IDAP REPORT

Property:	51 Oxford Road STRATHFIELD LOT 29 DP 2338 DA2022.69
Proposal:	Demolition of the existing dwelling house and construction of a new two (2) storey dwelling house with a basement and swimming pool with associated outbuilding.
Applicant:	Steve Wu Architects Pty Ltd
Owner:	Y Chen
Date of lodgement:	4 April 2022
Notification period:	13 April 2022 – 30 April 2022
Submissions received:	Nil
Assessment officer:	J W Brown
Estimated cost of works:	\$1,870,000.00
Zoning:	R2-Low Density Residential - SLEP 2012
Heritage:	No
Flood affected:	Yes
Is a Clause 4.6 Variation Proposed:	N/A
RECOMMENDATION OF OFFICER:	APPROVAL

Figure 11: Clouding of the louver where balcony will be reduced.

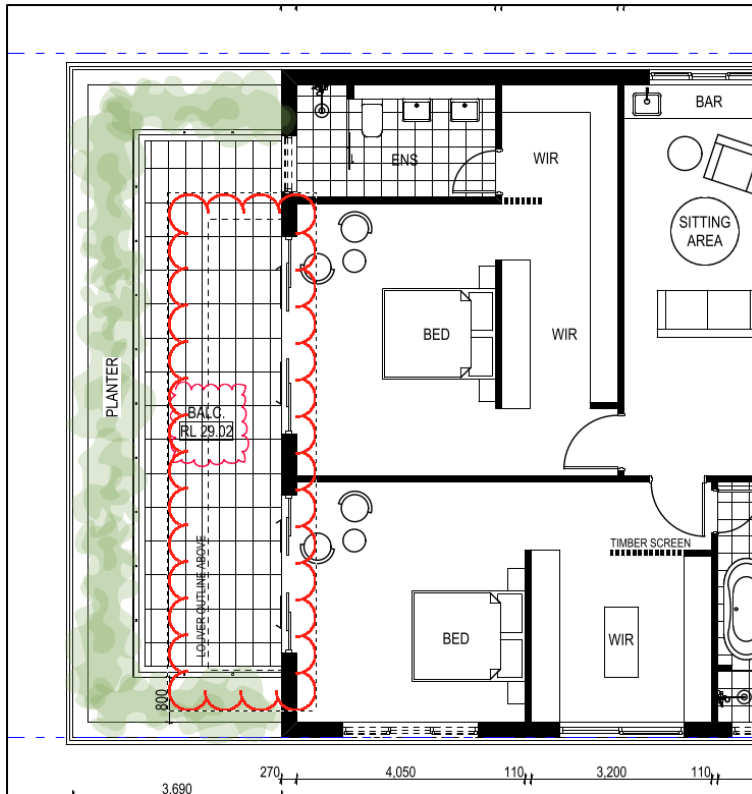
The rear balcony on the first floor of the development is considered excessive and likely to cause issues with privacy and creates unnecessary bulk to the rear of the dwelling. The SCDPC 2005 requires a maximum depth of 1m and a width of 2m for rear balconies unless the balcony can demonstrate that it will not unreasonably impact on privacy of adjoining neighbours. The proposal in its current form does not demonstrate this, thus it will be conditioned to be reduced to the depth and width of the louvred awning above (Figure 11) with the remaining portions of the roof structure to be non-trafficable. This will reduce the scale of the balcony limiting its use and reduce the bulk of the development at the rear.

Parapet height	The maximum parapet height above the uppermost ceiling level is to be 0.8m
Rear Balcony	The rear balcony must be reduced to the size of the louver outlined above and the rest of the rood structure must be non-trafficable
Basement Storage Room and Plant Room	The basement storage room is to be reduced by 20m ² . The floor to ceiling height of the storage room and plant room is to be reduced to a maximum 2.2m.
Driveway width at boundary	The vehicular access driveway width must be reduced from the proposed 3.5 metres to 3 metres to achieve a maximum allowed width of 3m at the boundary. Any front fence or gate opening adjustments required as a result of this reduction must be illustrated on the plans lodged with the application for the Construction Certificate.
Outbuilding height	The outbuilding must have a maximum height of 3.5m above natural ground level
Rear Alfresco	The rear alfresco must be a maximum of 500mm above natural ground level
